Proposed Residential Development, Glen Dimplex, Stoney Lane, Whiston – Transport Technical Note 01 – July 2026

- 1 BTG Eddisons has been instructed by Taylor Wimpey to advise on the traffic and transport issues relating to the proposed residential development on land at Stoney Lane in Whiston (Planning Ref: 25/00672/FUL).
- 2 This Transport Note has been produced in response to the consultation responses received from Knowsley Metropolitan Borough Council (KMBC) on 24th May 2026.

DRAWING TITLE: PROPOSED SITE ACCESS

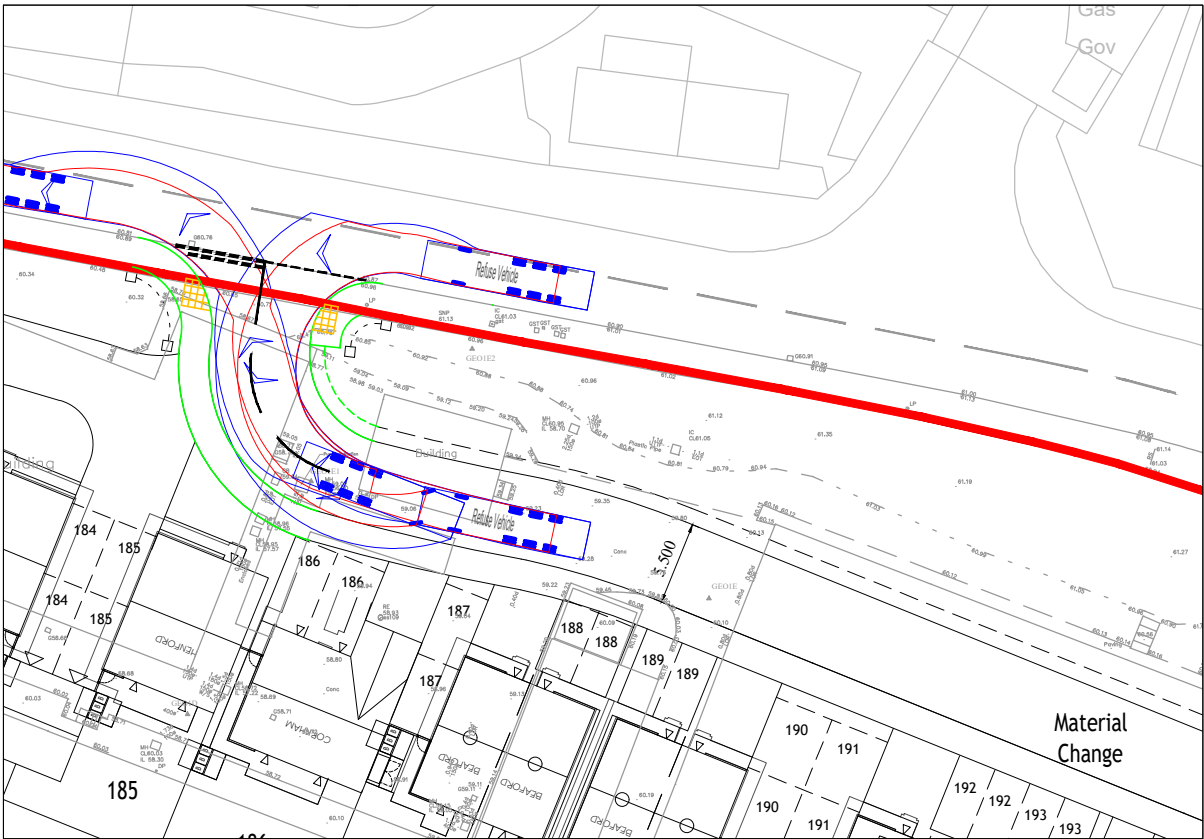
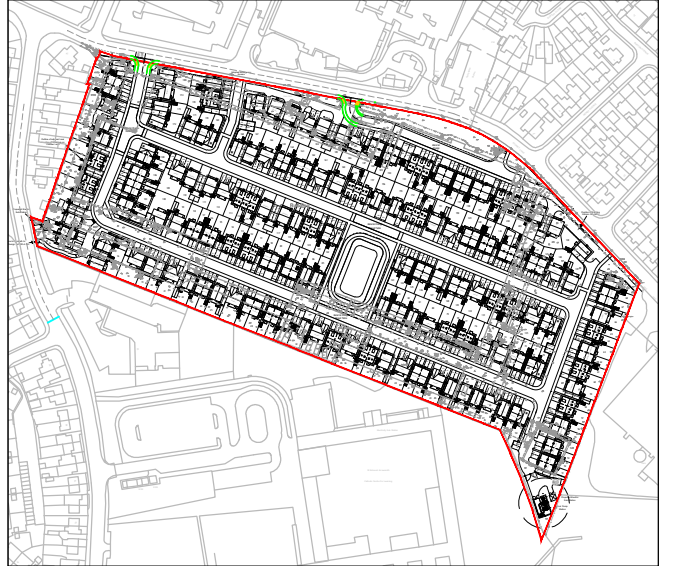
“At pre-application stage, highways raised concern regarding the positioning of any residential access opposite the operational accesses serving the Ambulance Station on Stoney Lane. Although the applicant has marginally repositioned the access serving the cul-de-sac fronting Stoney Lane, the revised location now sits almost directly opposite the ambulance station’s eastern access. This remains unacceptable.

Routine residential turning movements would directly conflict with emergency vehicle egress, particularly during blue-light departures where ambulances require immediate, unobstructed priority. Opposing accesses in such close proximity increase driver hesitation, complicate decision-making, and introduce avoidable obstruction risk. Given that there is a clear length of frontage between the ambulance station’s two accesses where a residential junction could be positioned without directly opposing either, the current arrangement represents a design choice rather than a constraint.

The access should therefore be repositioned to remove direct conflict with emergency operations and maintain a predictable, low-conflict highway environment.”

"The planning layout shows a number of "emergency-only" vehicular accesses around the site perimeter, significantly more than would normally be required for a development of this scale. While pedestrian and cycle permeability is strongly supported, the number of vehicular emergency accesses proposed is excessive and unjustified.

The emergency accesses positioned on Stoney Lane create unnecessary frontage breaks, undermine hierarchy, and increase the likelihood of informal vehicular use over time. Standard practice would typically expect no more than one well-located emergency vehicular access if deemed it was required operationally. If a single emergency vehicular access is required, the access located near Plot 138 is the preferred location. The emergency access strategy therefore requires rationalisation, with vehicular emergency access reduced to a single appropriate location, and all other boundary breaks redesigned as pedestrian and cycle links only.

All other boundary breaks currently shown as "emergency access" should be removed or redesigned for pedestrian/cycle use only. Any retained emergency access must be supported by a clear, enforceable management plan and all must show that they meet current visibility requirements on a scaled plan"

"Of particular concern is the swept path at the cul-de-sac access fronting Stoney Lane, where the tracking for the refuse vehicle demonstrates significant overrun across the full width of the junction, fully encroaching into the area of pedestrian waiting space at the junction, including the tactile paving, thereby removing any safe standing area for pedestrians awaiting a crossing opportunity. This compromises the safety of anybody standing at the tactile crossing area. Further to this, the swept path drawings show that refuse vehicles exiting the estate from both accesses onto Stoney Lane are required to significantly overrun opposing lanes to a degree that exceeds what would normally be considered acceptable onto a busy distributor road. These arrangements present an unacceptable risk at a location that already experiences high pedestrian activity.

- 5 The site access is now positioned approximately 15 metres to the west, as shown on **Plan 1**.

- 7 The revised emergency access will be located between the two access points by Plot 176 is shown on **Plan 1**. The emergency vehicular access will be adopted.

64 The revised vehicular access arrangement is shown on Plan 1.

109 The amended site access arrangement incorporating the recommended 'Keep Clear' markings is shown on Plan 1.

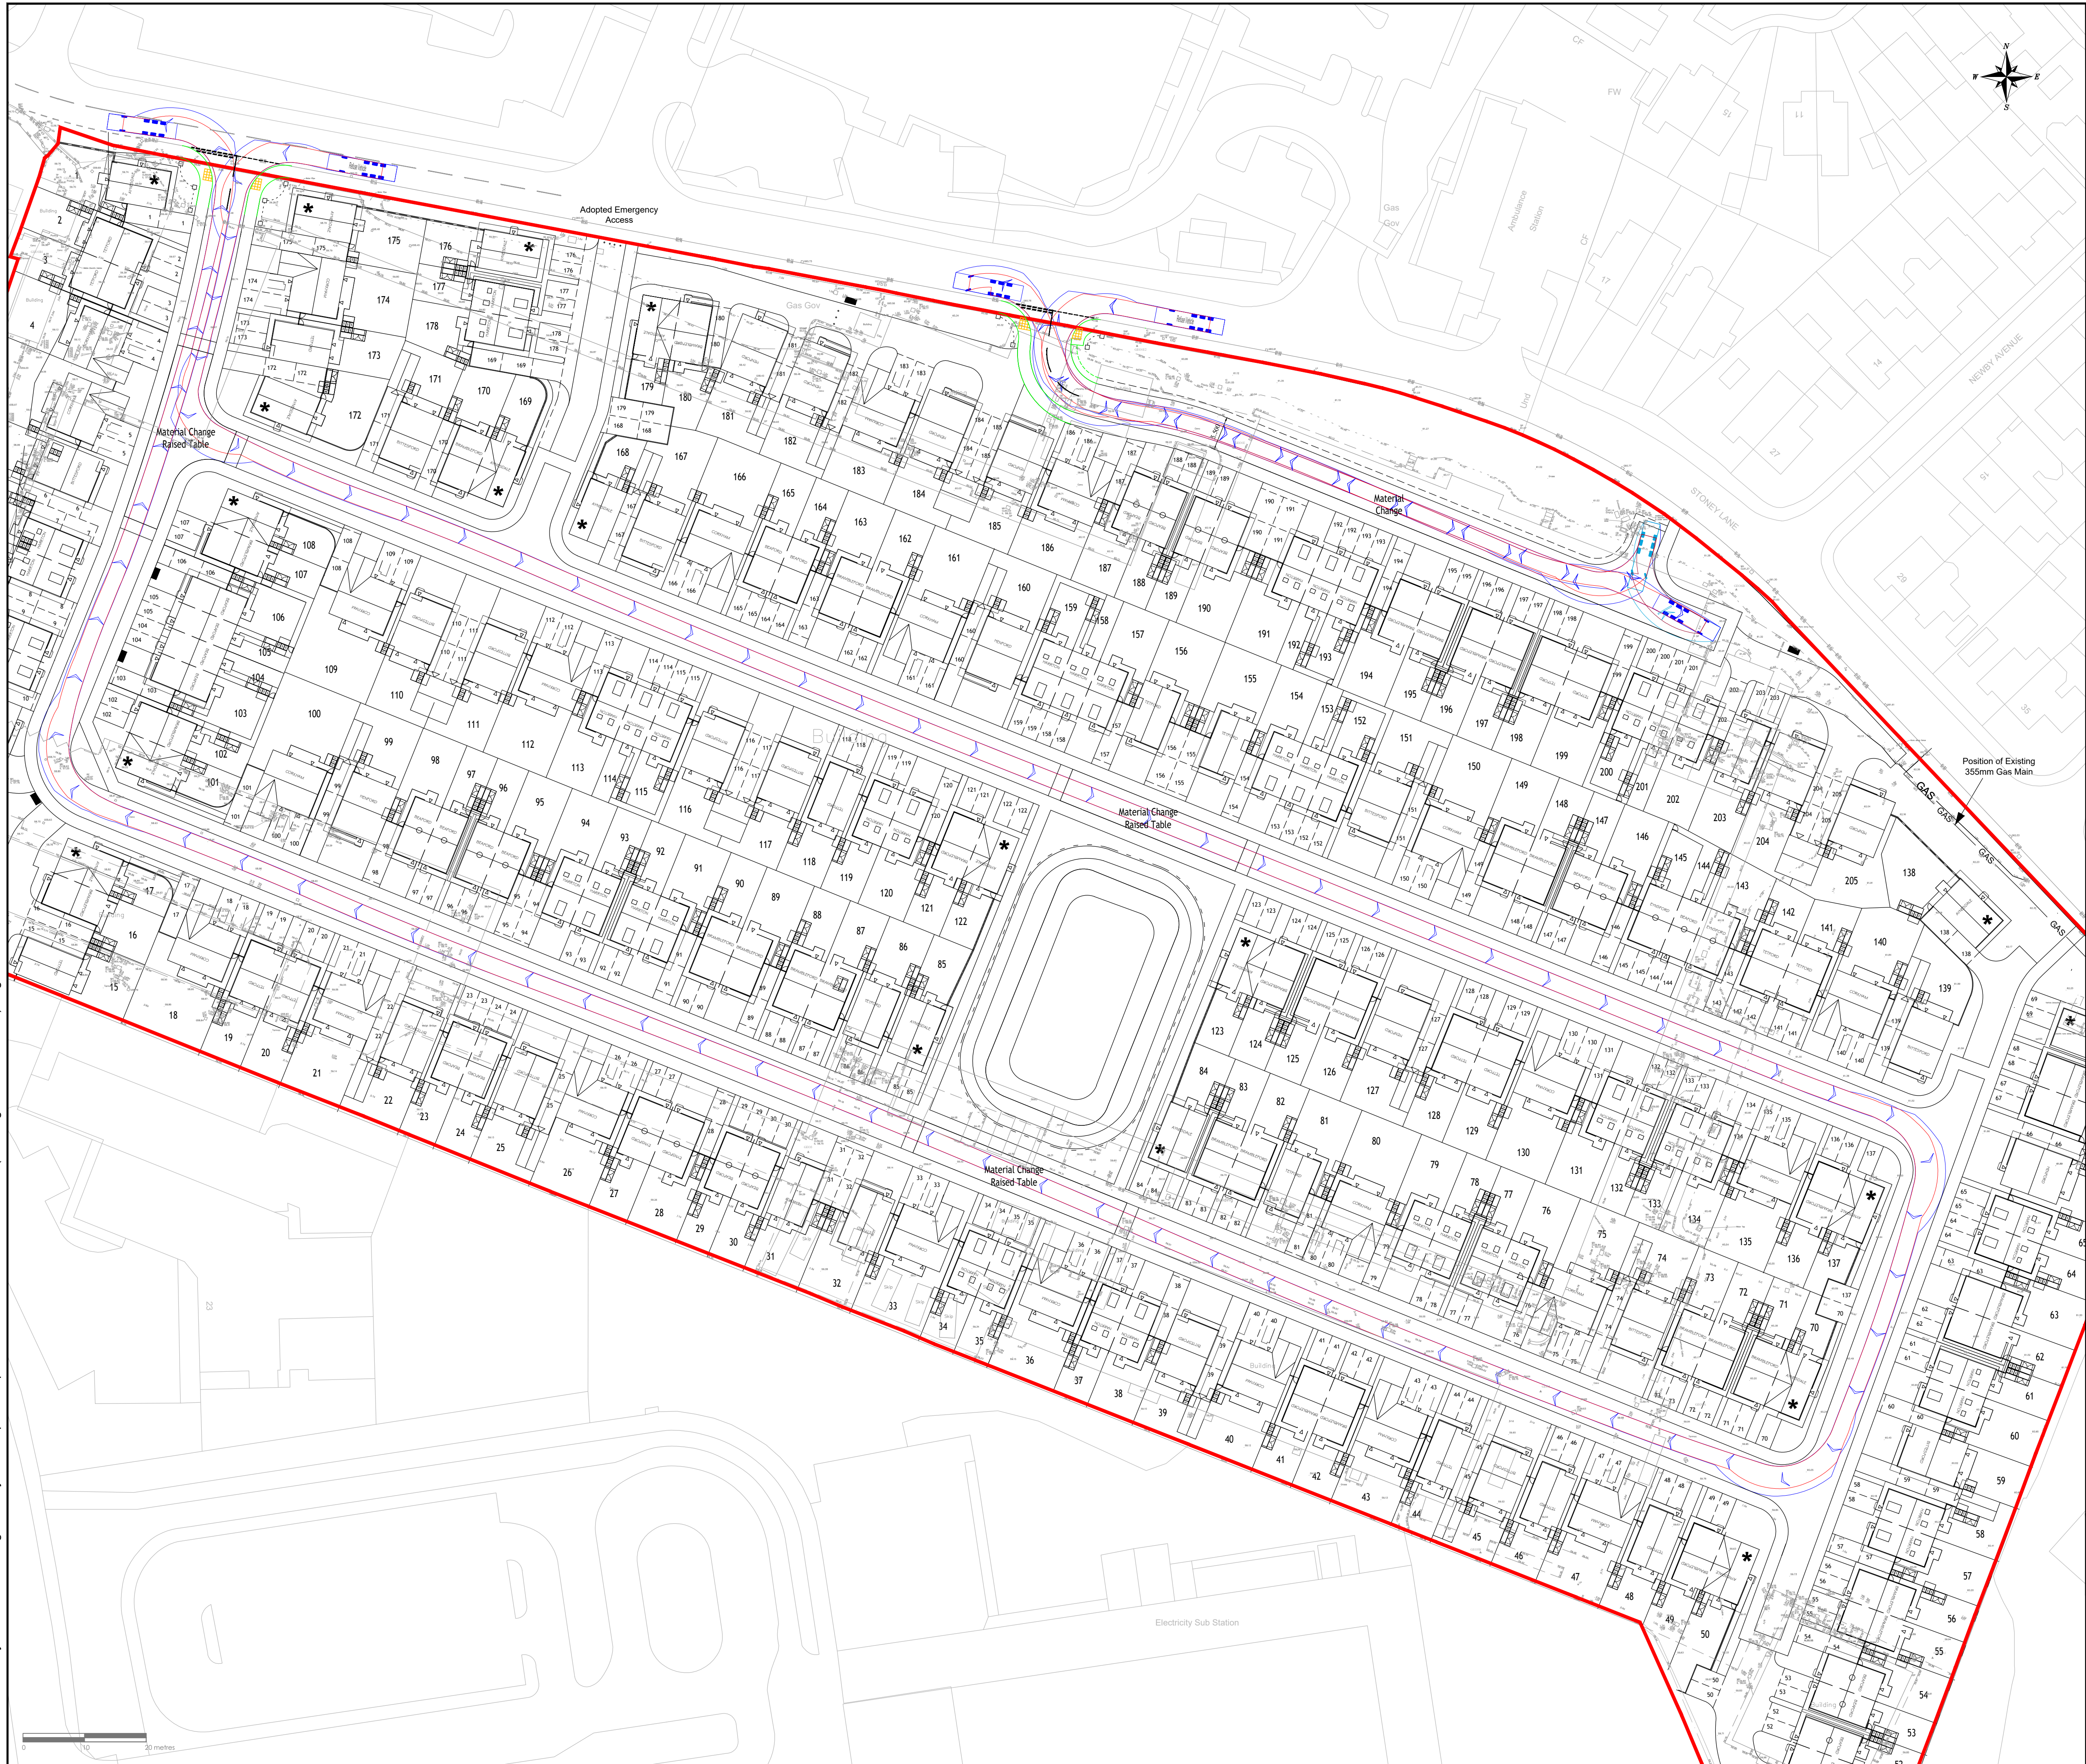
"The plan also shows the pumping station accessed from a privately managed drive, which is unacceptable. Pumping stations require reliable access for 12 m tankers directly from an adopted highway, with provision for forward entry and exit. The proposed arrangement presents unacceptable risks relating to access rights, surface condition, maintenance liability and operational resilience.

59 The swept path analysis of the 12-metre tanker vehicle is shown in **Plan 4**.

66 The turning area for the tanker has now been redesigned to allow it to enter and leave in a forward gear. The swept path analysis for the tanker is shown on Plan 4.

Location of Identified Problems

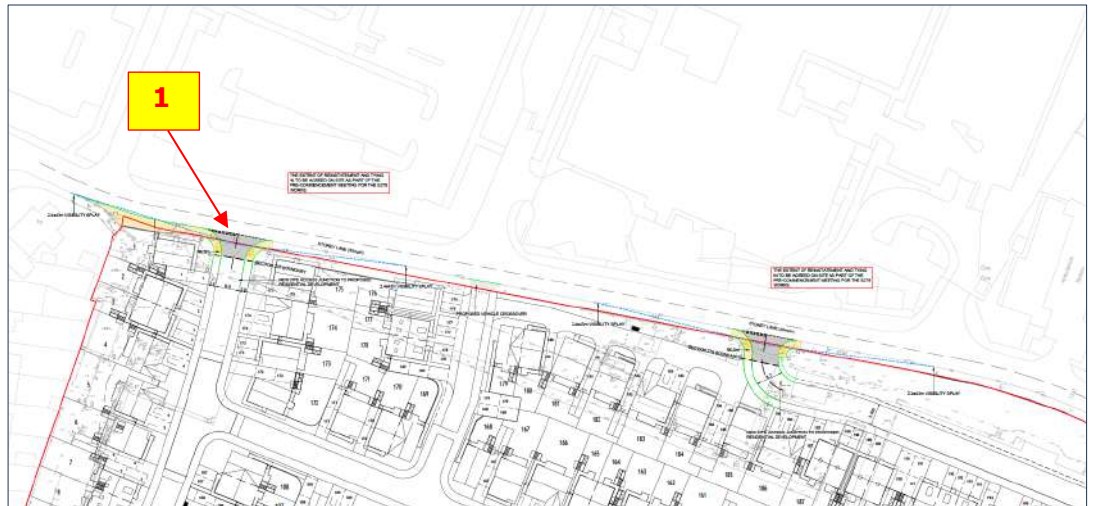
"A Stage 1/2 RSA must be submitted at planning stage and cover:

110 The Road Safety Audit is contained within **Appendix 11**, whilst the Designer's Response is contained within **Appendix 12**.
